VALUE ENGINEERING TRAINING STUDY REPORT

SR 166 / US 27 Interchange Reconstruction

Project No. NH-017-1(22)
Carroll County
PI No. 621990
November 12, 2009

DEVELOPMENT PHASE - EXECUTIVE SUMMARY	
Project: US27/SR166 INTERCHANGE RECONSTRUCTION	Team: 3
Location: CARROLL COUNTY	Date: 10/22/2009

Sheet 2 of 11

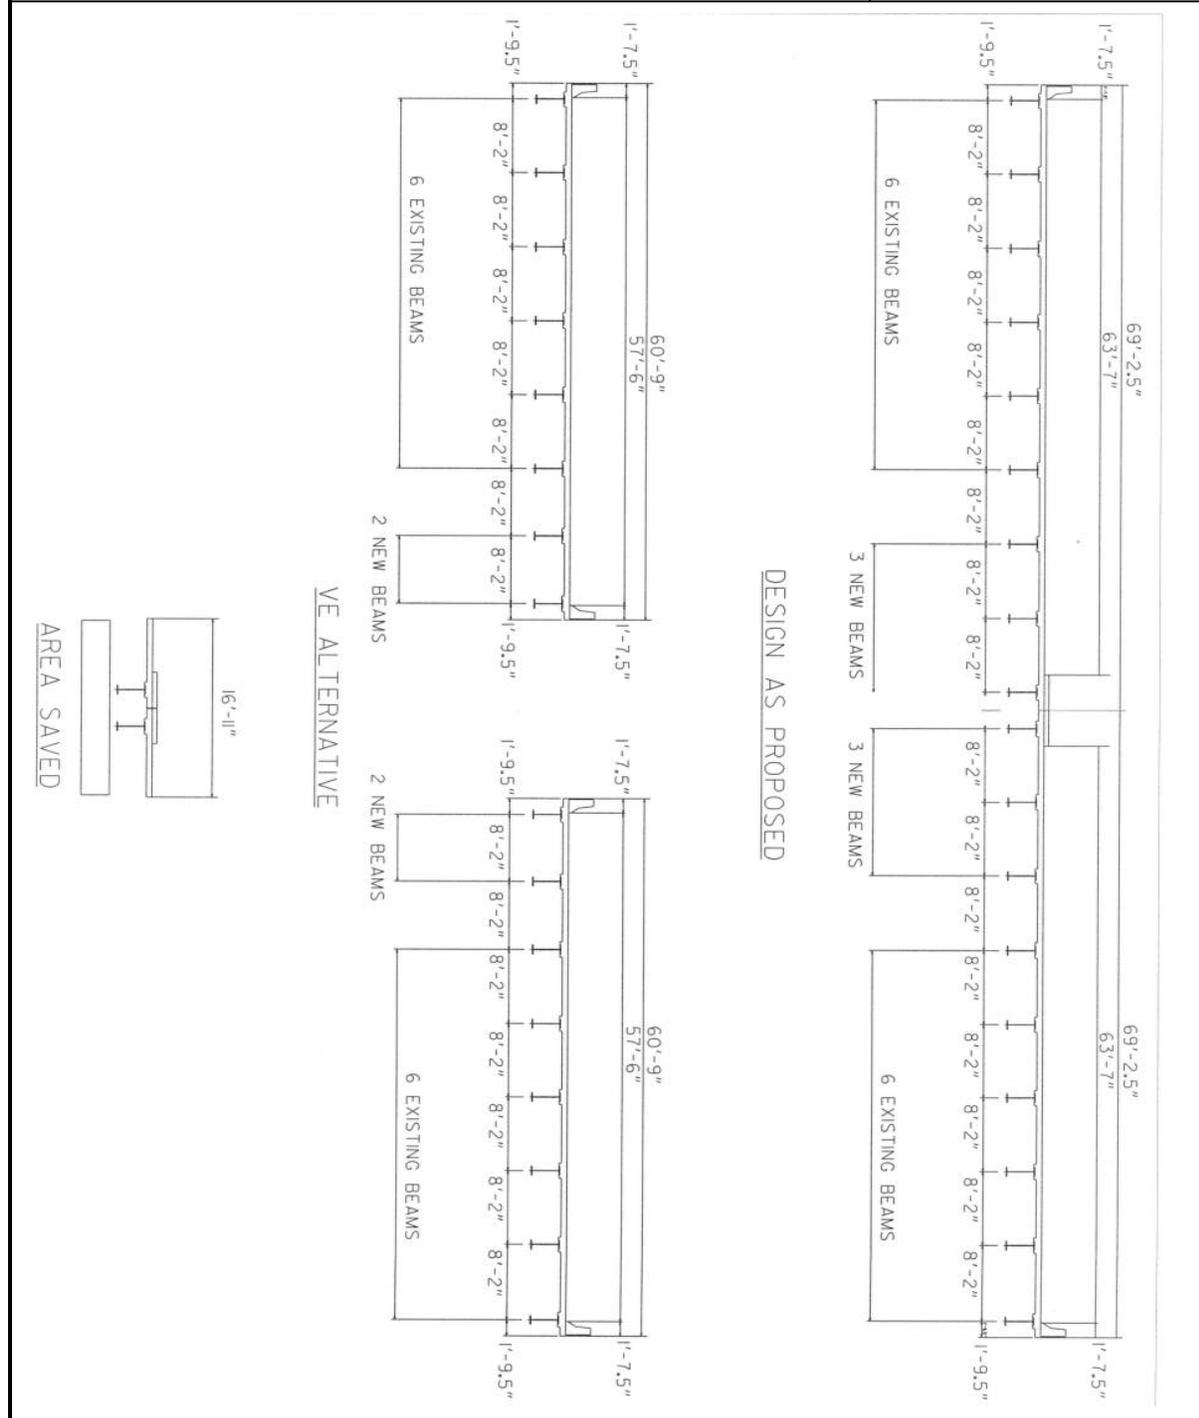
DEVELOPMENT AND RECOMMENDATION PHASE			
Project: US27/SR166 INTERCHANGE RECONSTRUCTION			
Idea No.: A-3-1	Sheet No.: 1 of 11	CREATIVE IDEA: DECREASE LANE & SHOULDER WIDTHS – MAINLINE	
Comp By: CP, JK & MW Date: 10/22/09 Checked By: MB & LJ Date: 10/22/09			
<p>Original Concept: The original concept proposes a typical section that includes 12-foot lanes and 12-foot inside and outside shoulders. To achieve this typical section, the existing parallel bridges would be widened and connected. The northbound and southbound lanes would be separated by a 16-foot median.</p> <p>Proposed Change: The proposed design recommends decreasing the lane widths to 11 feet. For the bridge, the inside shoulder width would be decreased to 5’-6” and the outside shoulder would be decreased to 8 feet. In this design the existing parallel bridges would remain and only widened approximately 16 feet to the inside. The new roadway design will include 11 foot lanes, 2 foot inside paved shoulder and 6 foot outside paved shoulder.</p> <p>Justification: By changing the original concept, the cost of widening the bridge would be reduced. Additionally, the quantities of asphalt and graded aggregate base items would be decreased.</p>

LIFE CYCLE COST SUMMARY	INITIAL Project Cost	FUTURE Project Cost	TOTAL Present Worth Cost
INITIAL COST: Original	\$2,477,000		
Proposed	\$2,051,000		
Savings	\$426,000		
FUTURE COST: Savings			
TOTAL PRESENT WORTH SAVINGS			\$426,000

TYPICAL SECTION
VE ALTERNATIVE
OFF BRIDGE

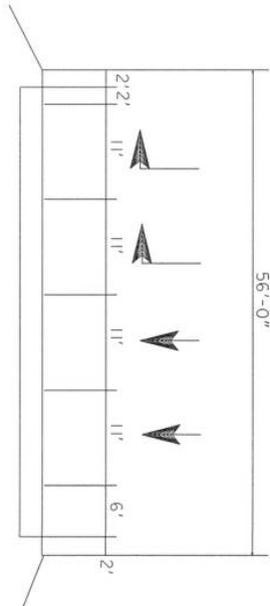
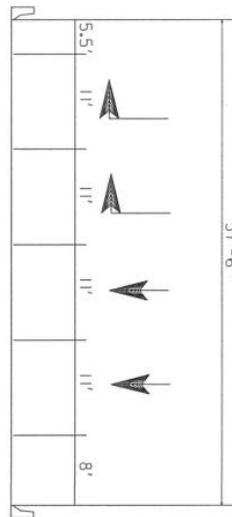
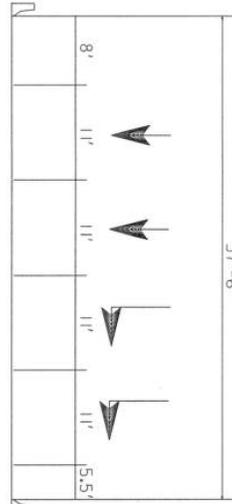
TO MAXIMIZE THE VALUE OF THIS PROPOSAL BOTH LANES AND SHOULDERS MUST BE REDUCED.
 THIS ALLOWS THE REMOVAL OF 2 BEAMS PER SPAN.

Idea No. : D-3
Client:: GDOT
Sheet 2 of 3

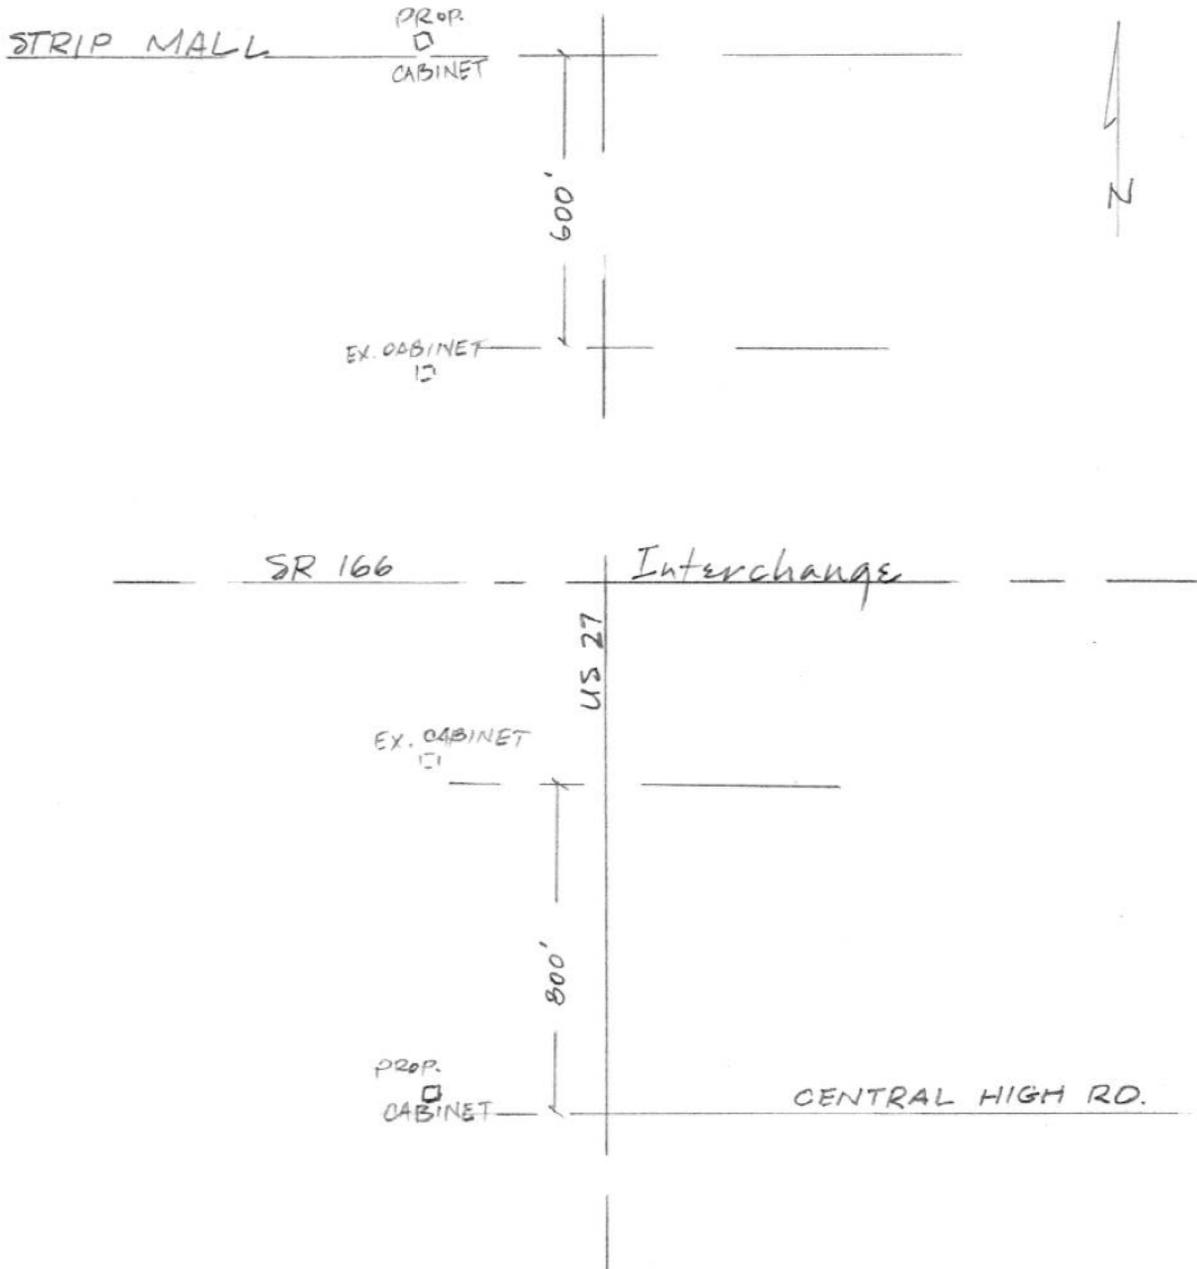
DEVELOPMENT AND RECOMMENDATION PHASE			
Project: US27/SR166 INTERCHANGE RECONSTRUCTION			
Idea No.: D-3	Sheet No.: 1 of 3	CREATIVE IDEA: MODIFY TIMING – INTERCONNECT SIGNALS	
Comp By: LJ	Date: 10/22/09	Checked By: MB & JTC	Date: 10/22/09
<p>Original Concept: The original design only called for interconnecting the signals at the ramps of the US27/SR166 interchange.</p> <p>Proposed Change: It is recommended that the signals at the ramps of the interchange be interconnected to the existing signals along US27 that are directly adjacent to the project. This would include interconnect for the signals at the entrance to the strip mall north of the project and Central High Road which is south of the project.</p> <p>Justification: By interconnecting adjacent signals on US27, traffic operations would be improved at the US27/SR166 interchange, therefore improving LOS, capacity and overall operations. This would better manage traffic demand that is currently concentrated at the interchange. This is a relatively low cost change that would increase capacity and traffic operations, which adds a higher value to the project for minimum cost increase.</p> <p>NOTE: In our analysis of the traffic signal items, we found additional quantities that could be eliminated by reusing existing materials. Upon verification with the project manager, it was determined that actual estimated cost for items related to the traffic signals was approximately \$55,000 instead of \$271,000.</p>

LIFE CYCLE COST SUMMARY	INITIAL Project Cost	FUTURE Project Cost	TOTAL Present Worth Cost
INITIAL COST: Original	0		
Proposed	\$98,000		
Savings	(\$98,000)		
FUTURE COST: Savings			
TOTAL PRESENT WORTH SAVINGS			(\$98,000)

TYPICAL SECTION No. 16

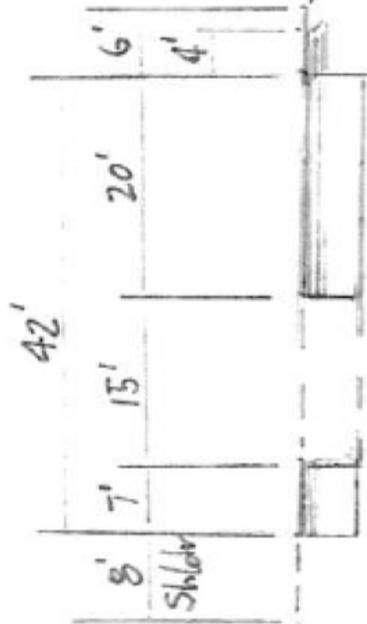
DEVELOPMENT AND RECOMMENDATION PHASE			
Project: US27/SR166 INTERCHANGE RECONSTRUCTION			
Idea No.: K-1	Sheet No.: 1 of 4	CREATIVE IDEA: WIDEN RAMP C TO INSIDE	
Comp By: JTC & KC Date: 10/22/09 Checked By: MB & LJ Date: 10/22/09			
<p>Original Concept: The current design of the westbound SR166 Off Ramp (Ramp C) proposes to widen the ramp to the outside of the interchange. This facilitates the need to acquire right of way.</p> <p>Proposed Change: The proposed change is to widen the westbound SR166 Off Ramp (Ramp C) to the inside of the interchange.</p> <p>Justification: By widening the ramp to the inside of the interchange, the need to acquire right of way is eliminated. Additionally, the quantities for grading complete (Item 210-0100) will be reduced because less grading will be required than in the original concept.</p>			
LIFE CYCLE COST SUMMARY	INITIAL Project Cost	FUTURE Project Cost	TOTAL Present Worth Cost

INITIAL COST: Original	\$226,000		
Proposed	\$190,000		
Savings	\$36,000		
FUTURE COST: Savings			
TOTAL PRESENT WORTH SAVINGS			\$36,000
